WALLARAH 2 COAL PROJECT

Amendment to Development Application SSD-4974 Public Hearing 2 Response

PUBLIC HEARING 2 RESPONSE

FIGURE 2

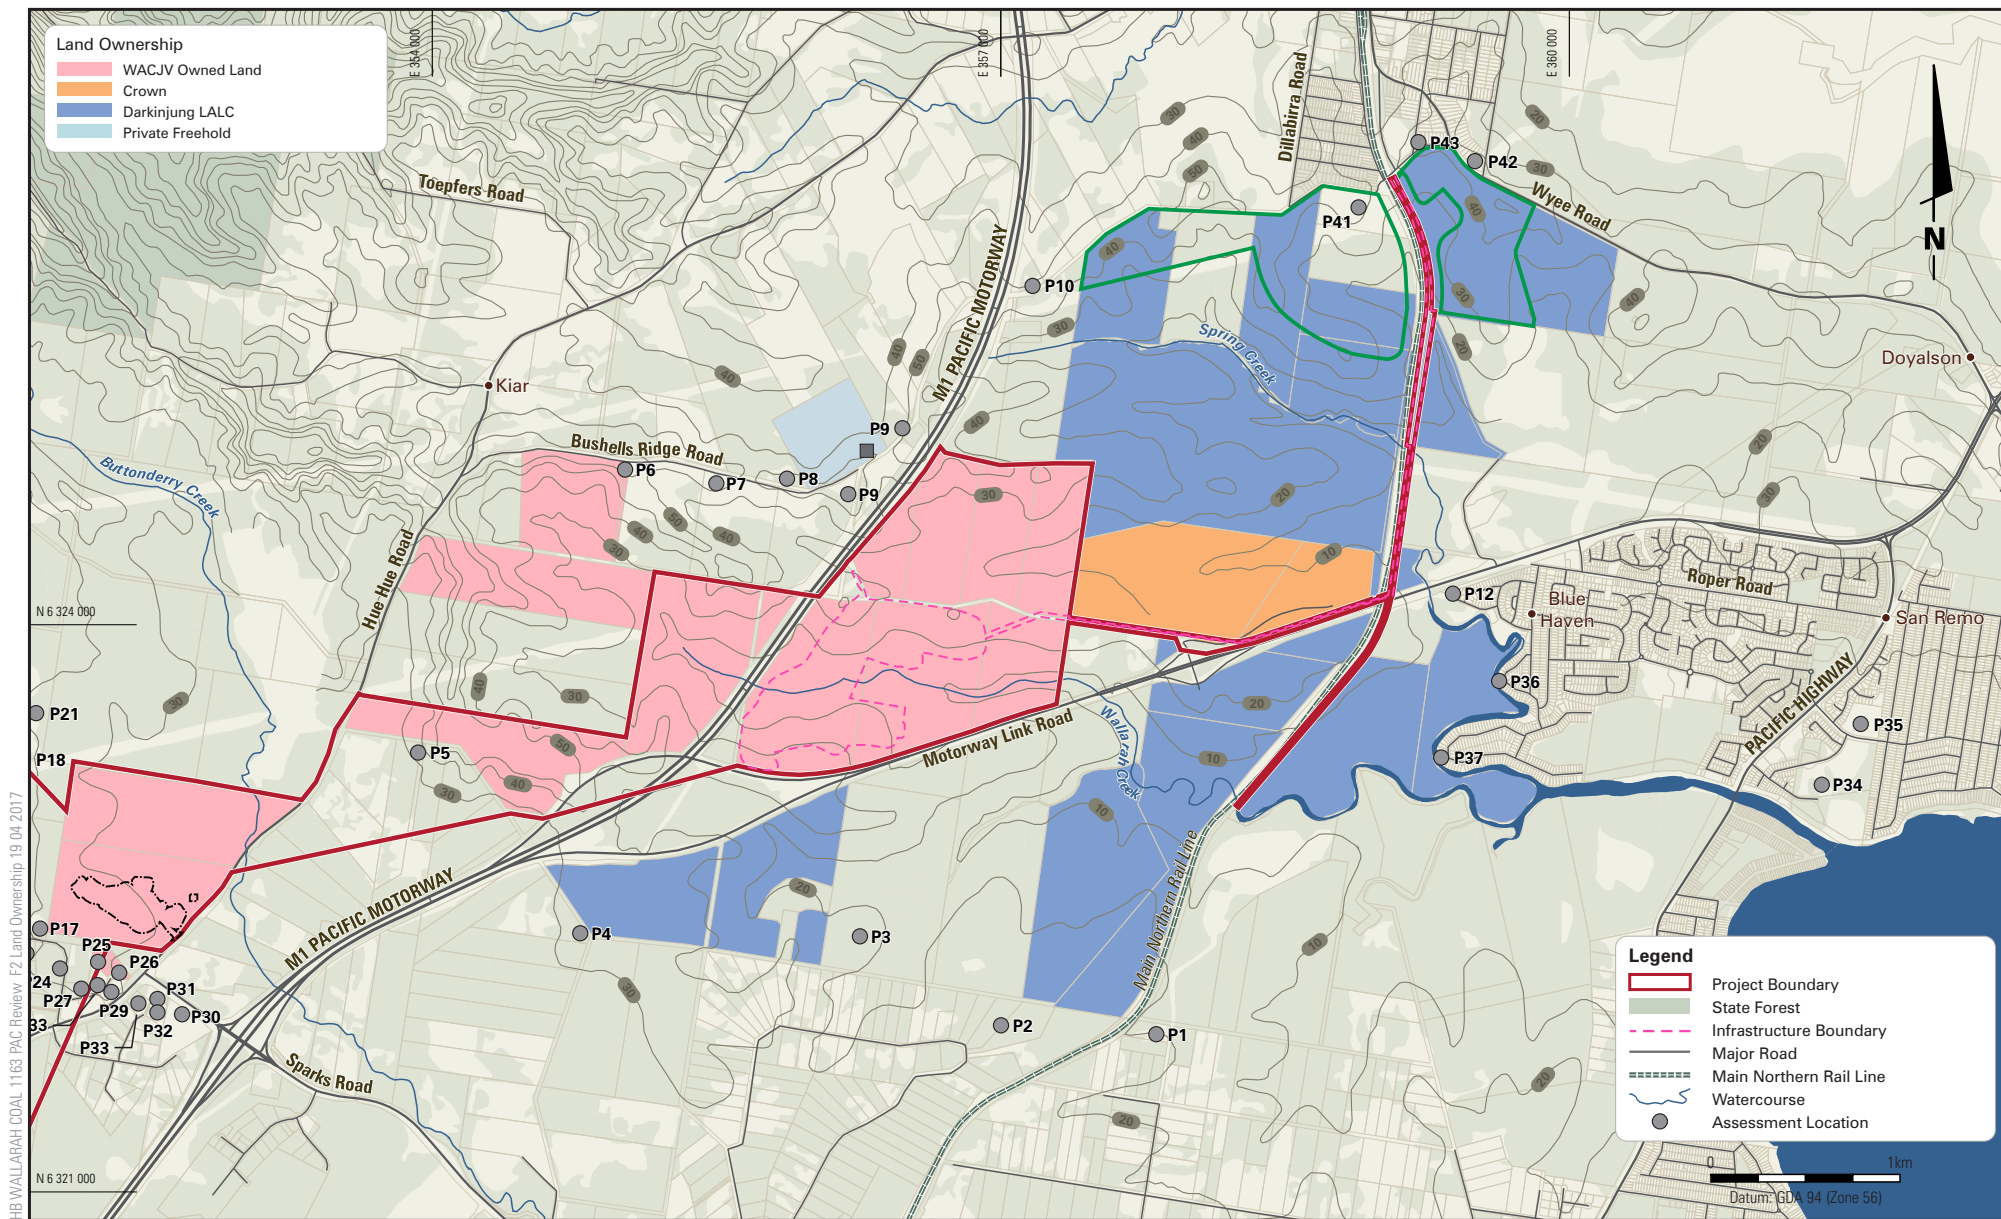
Figure 2 illustrates landownership with contours around the Tooheys Road Site and location of the B&J Cross property on Bushells Ridge Road as Property 63. Further, WACJV notes that B&J Cross raised the emergency access on Tooheys Road at a Doyalson consultation session.

At the same session Ken and Sue Drake (also Bushells Ridge Road residents) requested that more of Tooheys Road be closed because of the prevalence of burnt out cars and illicit drug taking at the M1 underpass.

Tooheys Road is the access to the Projects Tooheys Road site. The Tooheys Road site will be manned 24/7. Important, there is no intention to remove the road. It is however proposed to be gated to prevent through traffic for security reasons. Emergency services will have gate access.

See **Figure 2** which illustrates this resident's proximity to the Tooheys Road Site. The residence is 851 m north of the Project's product coal stockpile across a ridge. It should also be noted that the M1 Motorway effectively separates the residence from the Tooheys Road site and the coal stockpile.

FIGURE 4

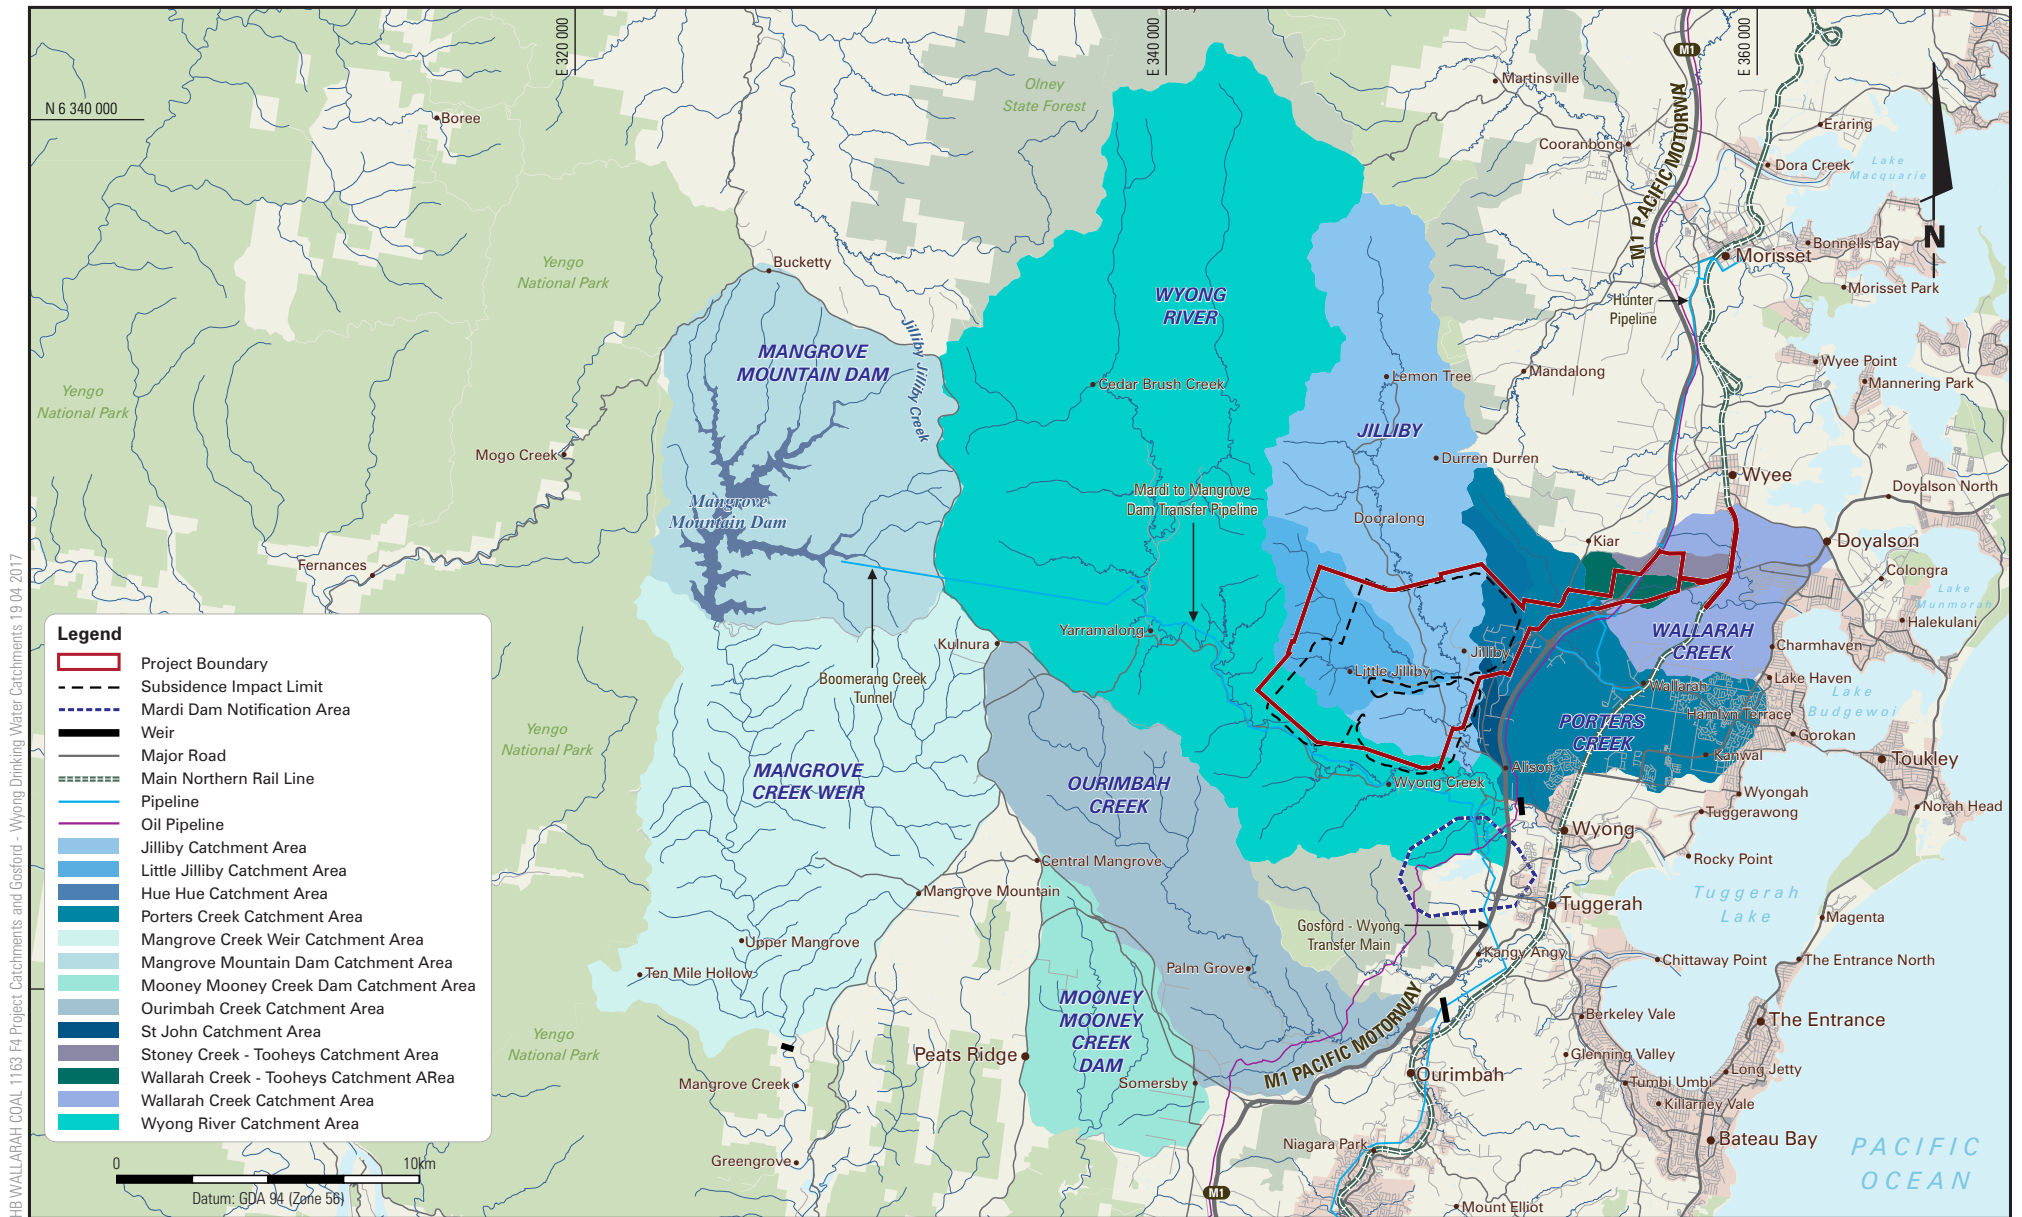
Please provide a drawing(s) to show the predicted angle of draw which will apply to the longwall panels.	3.11.1
Central Coast Council raised concerns about the potential subsidence impact on the Buttonderry Waste Management Facility.	3.11.2
Speakers at the Public Hearing pointed out that the Hue Hue Road Mine Subsidence Area only allows first workings. Please comment.	0
Central Coast Council expressed concerns that the area is a major growth area and road connectivity is an important issue.	3.12
The proposed closure of Nikko Road and Tooheys Road may impact on future road network planning.	
Have other options been considered to maintain these roads open and public?	
Speakers also raised that the Asset Protection Zones (APZ) should be provided on the applicant's land and not rely on adjacent land. Please advise whether the proposed rail loading facility includes an APZ, if required?	4.7.4
The Australia Institute's submission as presented at the Public Hearing is forwarded with this email. The Commission would like your further comments on the submission in relation to the operating costs and financial viability of the project.	4.11

Figure 4 shows the Project's 28 year underground longwall mining area and its relationship to the total surface area of the Central Coast Water Supply (CCWS) Catchment, adapted from Section 2.3.2 of the EIS.

Of the 72,700 ha of surface land catchments which supply the CCWS, the Subsidence Impact Limit (SIL) has been conservatively estimated for the 28 years of mining at 3,440 ha (down from 4,088 ha for the original 42 year Project). As such underground longwall mining will occur deep beneath less than 4.7% of the surface lands constituting the CCWS.

Figure 5 Conceptual Area Available for Parking at Nikko Road

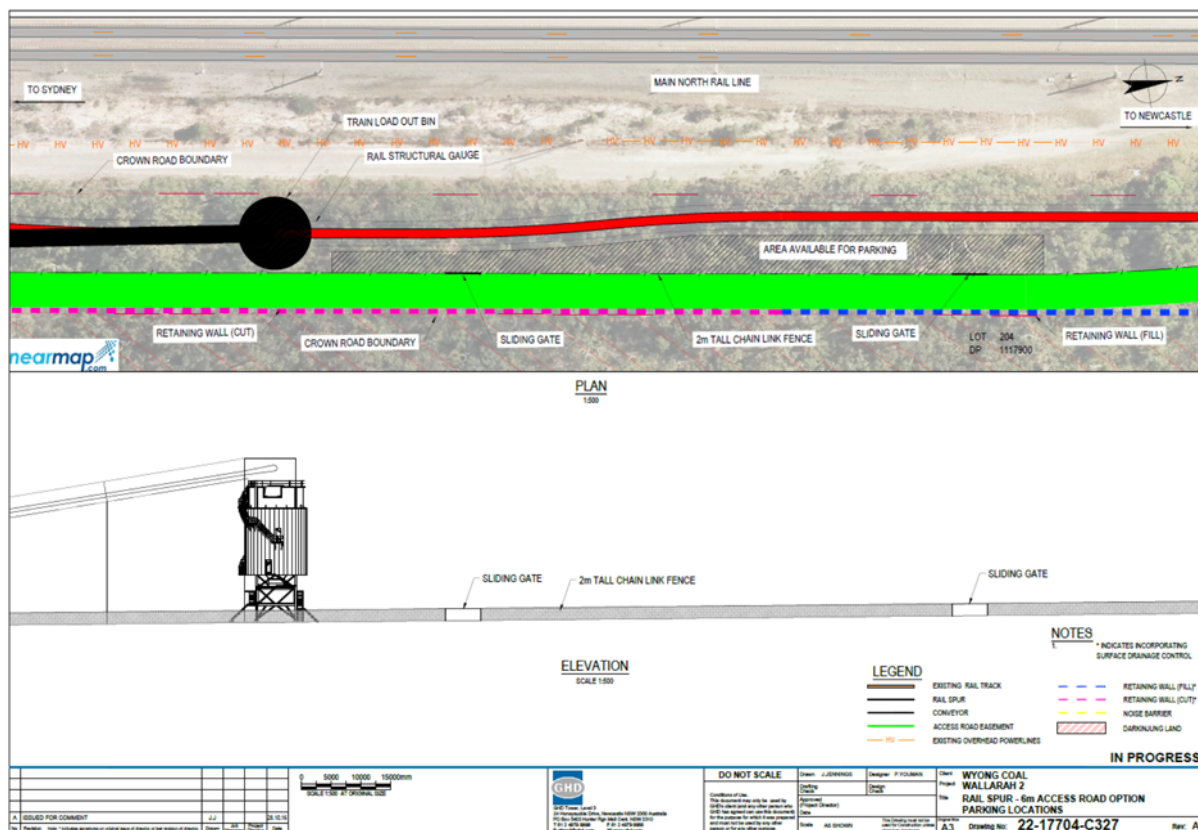
CCC expressed concerns that the area is a major growth area and road connectivity is an important issue. The proposed closure of Nikko Road and Tooheys Road may impact future road network planning. Have other options been considered to maintain these roads open and public?

With 14 m of the road being utilised for rail and access purposes, an approximate 6 m width area located centrally at the northern end of Nikko road is available for parking (when required) and service vehicle access as conceptually shown in **Figure 5**.

ADDENDUM 1: RTS (FIGURE 17)

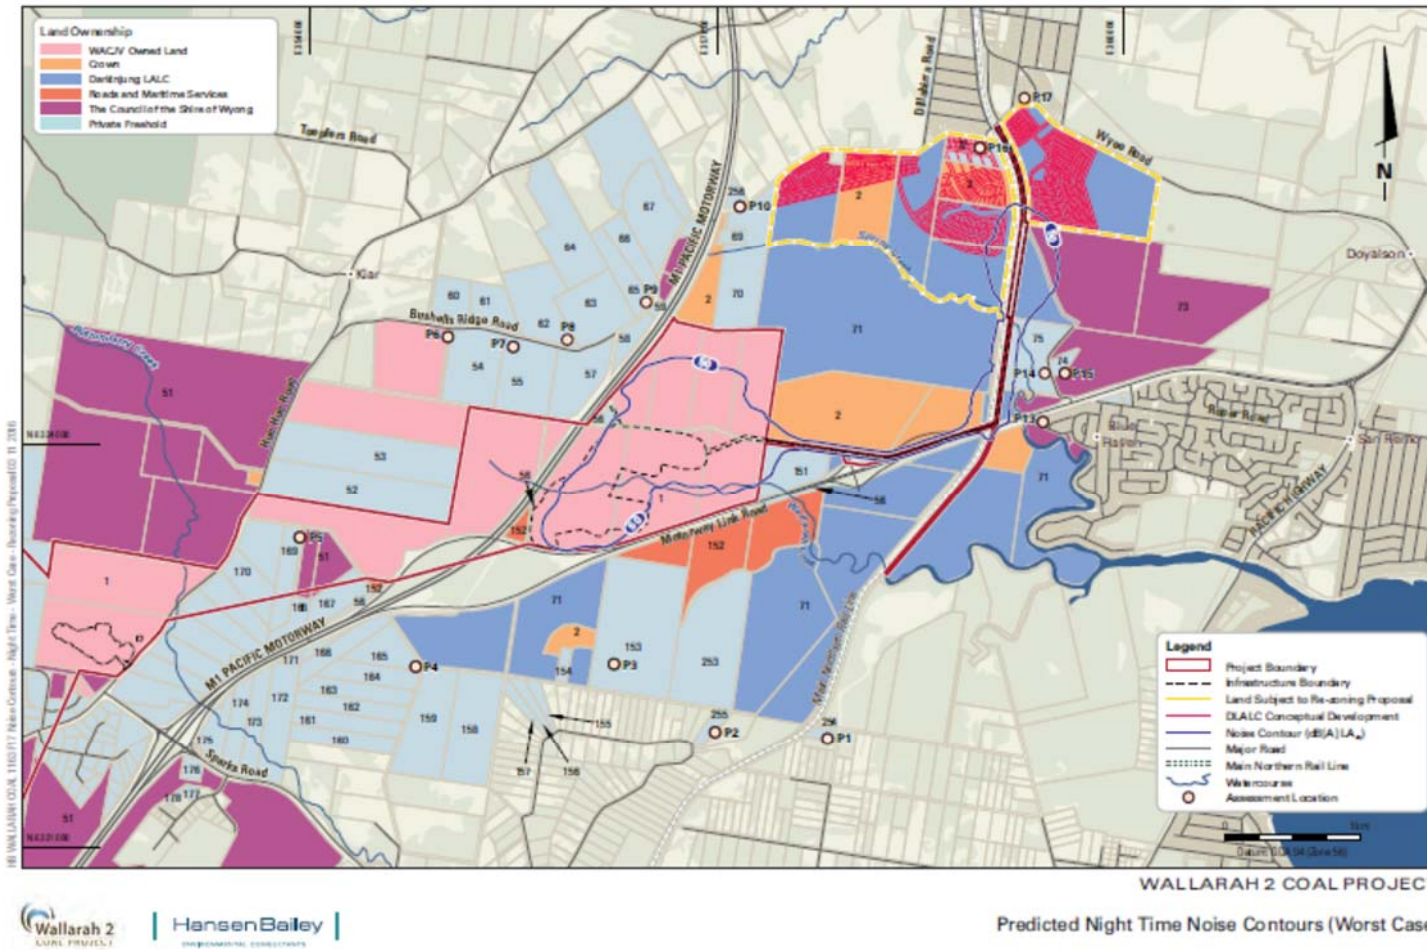
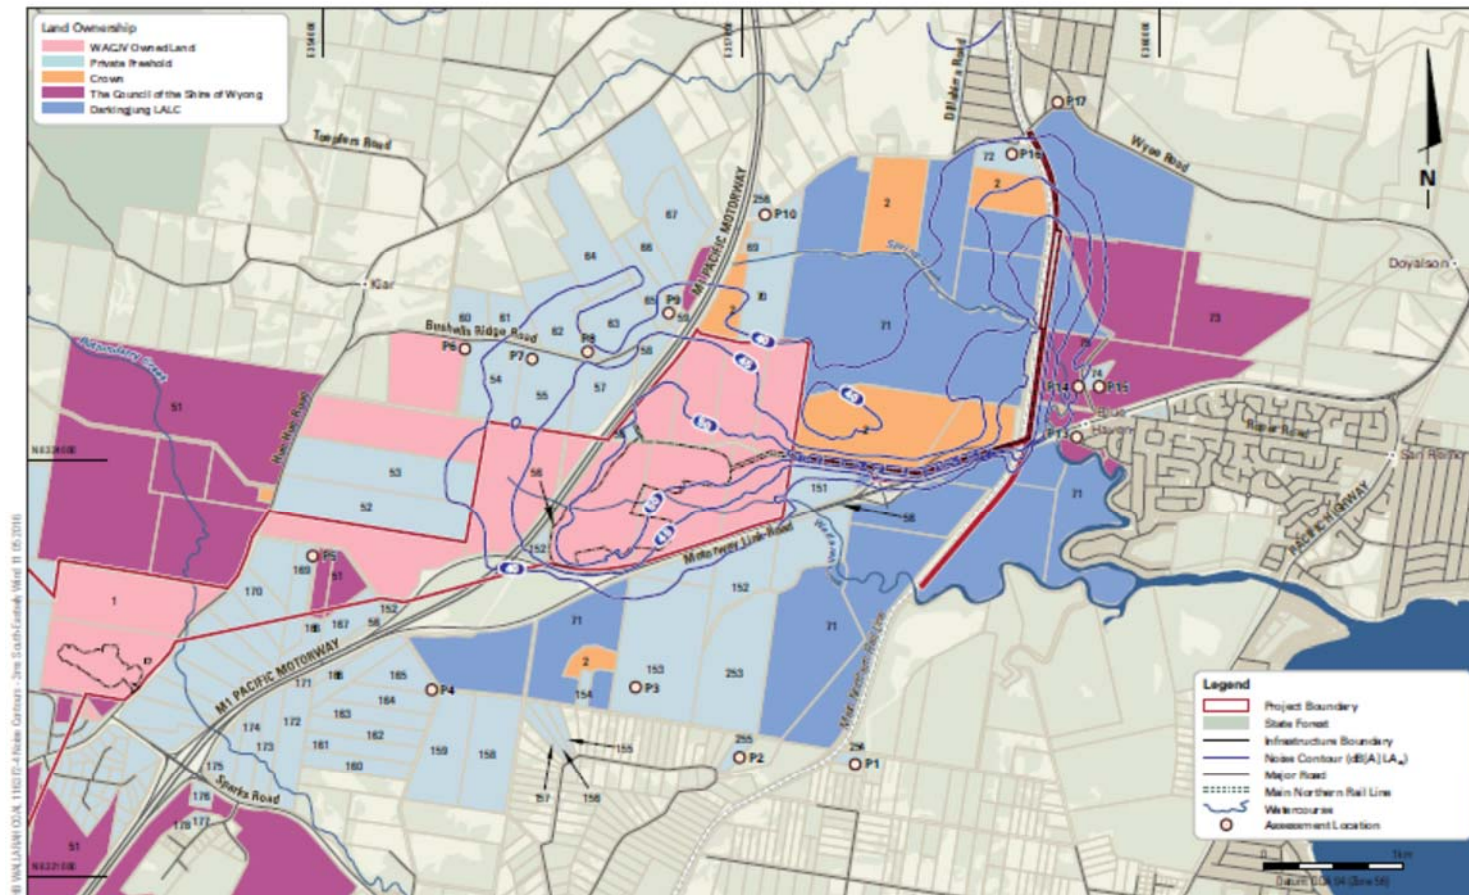
- 26.0 SA refers to the RTS (Figure 17) to reproduce SA Figure 1. Reviewing the SA noise contours it appears that the information was extracted from the Addendum Noise and Vibration Report (reproduced below at Addendum 2) not Figure 17 from the RTS (reproduced below at Addendum 1).

- 30.0 Reviewing the $L_{Aeq, 15min}$ adjustment assuming three coal trains per night (-3dBA), the predicted $L_{Aeq, 9 \text{ hour}}$ 50dBA contour would not occur on any Darkinjung land shown on RTS Figure 17 (Addendum 1). This further demonstrates the conservative approach to noise modelling applied to the Amended Project.
